# CITY OF BLACK DIAMOND

**Meeting Date:** October 12, 2021  
**Staff Report Date:** October 5, 2021  
**To:** Planning Commissioners  
**From:** Mona Davis, Community Development Director  
**Subject:** Comprehensive Plan Amendments – SE Loop Connector Alternative

The purpose of this staff report is to go over final docket item #2021-02: “Amendments to comprehensive plan Appendix 7 (Transportation) to reflect an alternative SE loop connector route.”

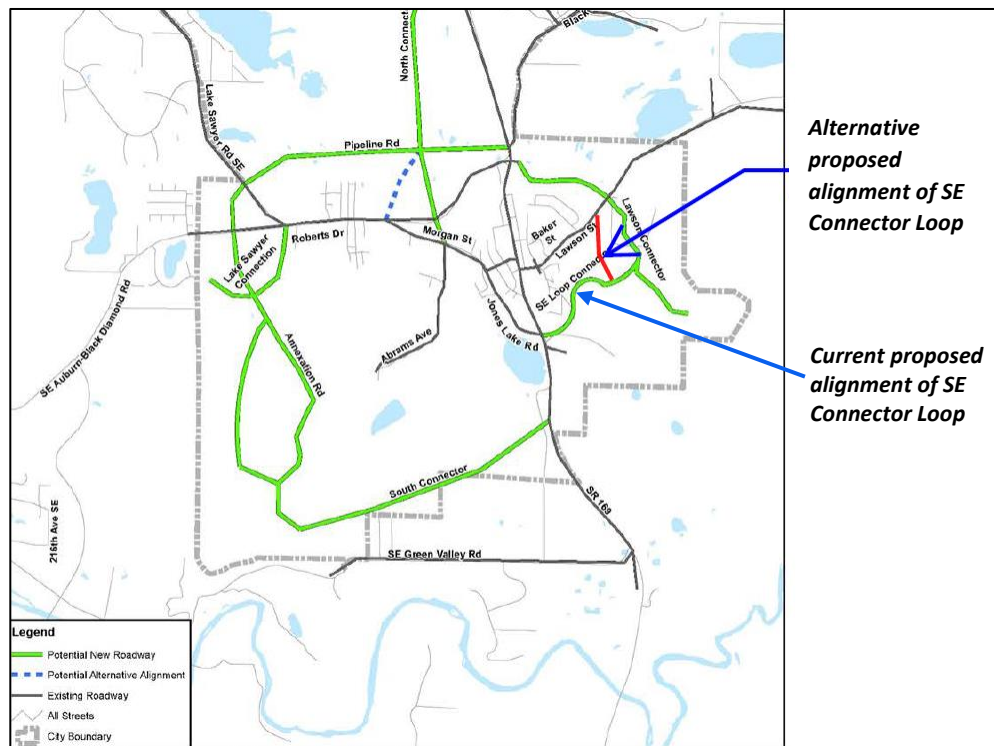
Language would be added to include the Southeast Loop Connector Alternative on the list that provides the planned classifications by roadway as follows (in red):

A conceptual configuration for the future roadway system in 2035 is shown in Figure 7-4. New arterial and collector roads include: Pipeline Road, Annexation Road, Lake Sawyer Extension, Lawson Connector, South Connector, Southeast Loop Connector **or Southeast Loop Connector Alternative**, and North Connector.
